OFFICE OF THE HISTORIC PRESERVATION COMMISSION

RE: HISTORIC PRESERVATION COMMISSION APPLICATION NO. HPC 2020-161 BLOCK 241, LOT 8 ALSO KNOWN AS 107 BROADWAY

Preliminary Review Notes

East Elevation

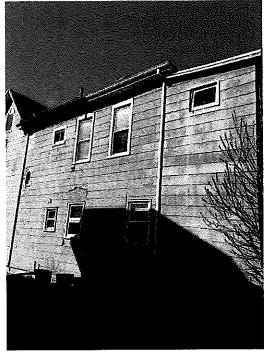
- 1. Historic appropriateness of the overall addition to be determined.
- 2. EAST ELEVATION:
 - a. Some windows appear to be altered in size and location
